Access Compliance Report

Public Rights-of-Way

(Curb Ramps)

Intersection ID: 46190	Main Street: YAUPON_RD	Cross Street: LUSTRE_RD	Location: SE
ADA ID: 2CE4C3764417	Ramp Type: Perp	Initial Pass/Fail: Pass	Overall Compliance: No
Severity Score: 5			
Codes/Mitigation Info/Possible Solution		Field Measurements/Component Compliance

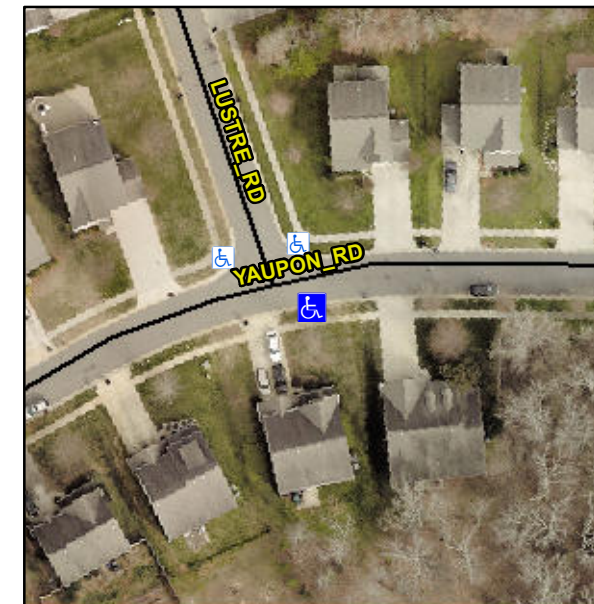
**Remove & Replace Entire Ramp.
Remove & Replace Gutter.**

Not Found, R305.2, R304.5.4
